Re: **DRB24-1026** – Narrative Responses to First Submittal  
Comments

### **DRB PLANNING REVIEW**

Draft Notice: DRB24-1026 94 Palm Ave: An application has been filed requesting Design Review Approval for the construction a new two-story residence with an understory level, including one or more waivers, to replace an existing residence.

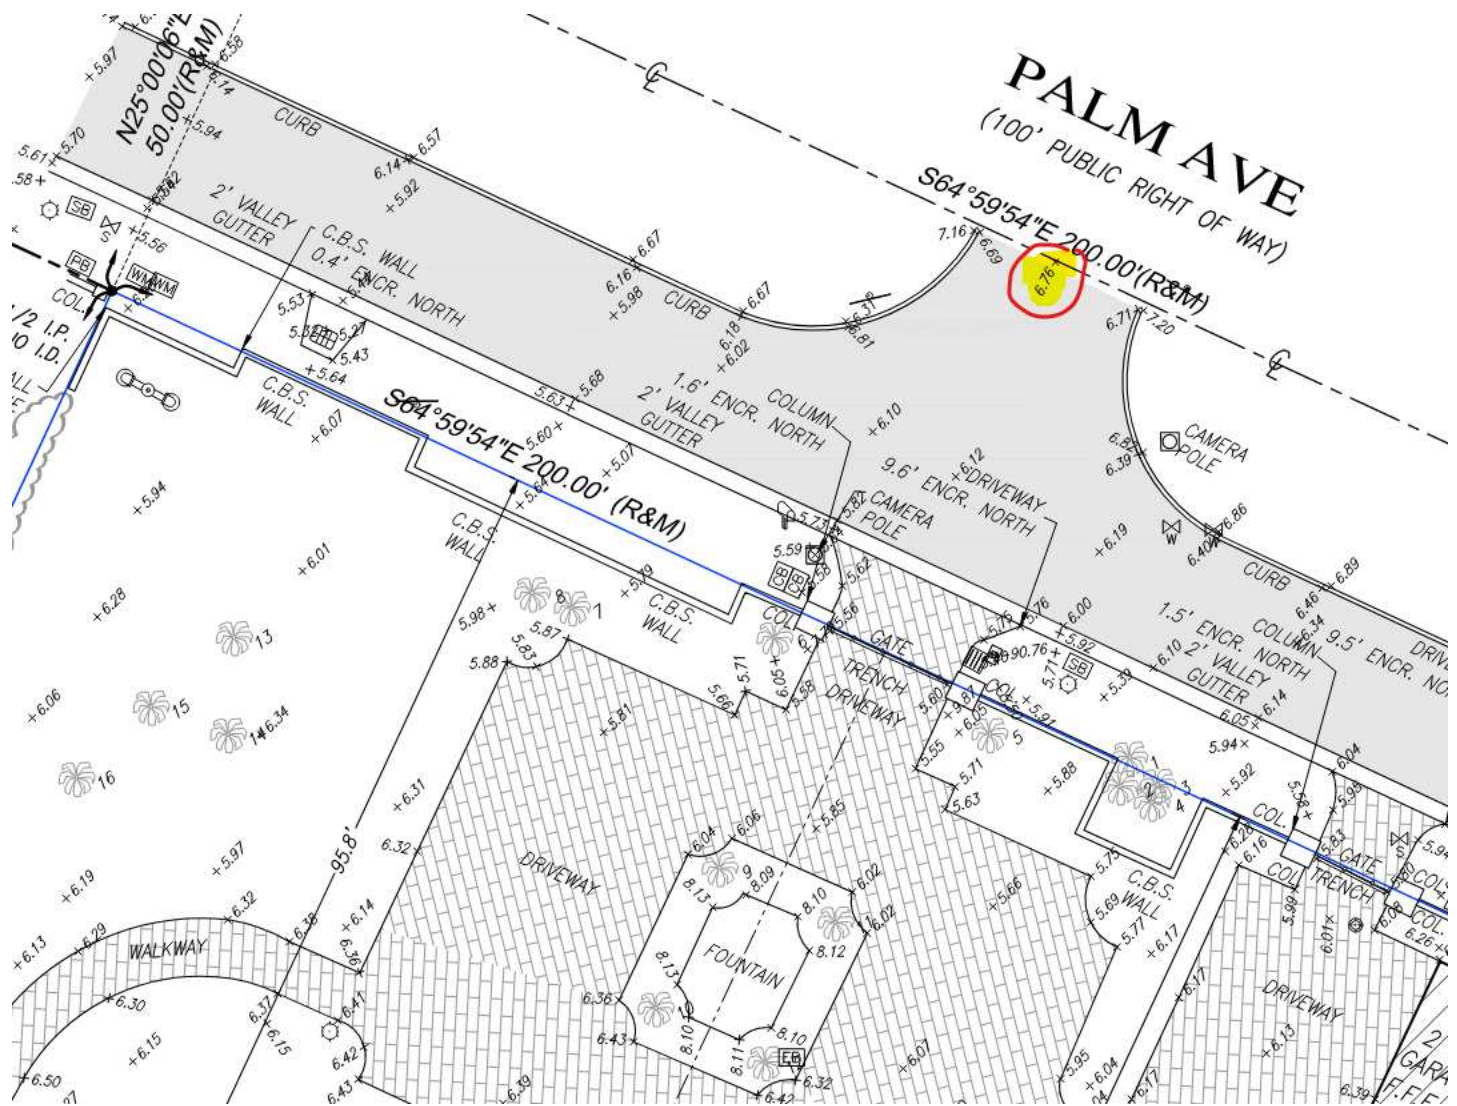
Would you consider the highlighted number below: 6.76' as the crown of road?

The roads in Palm Island were raised already. Please use the existing crown of road for the Future Crown of Road.
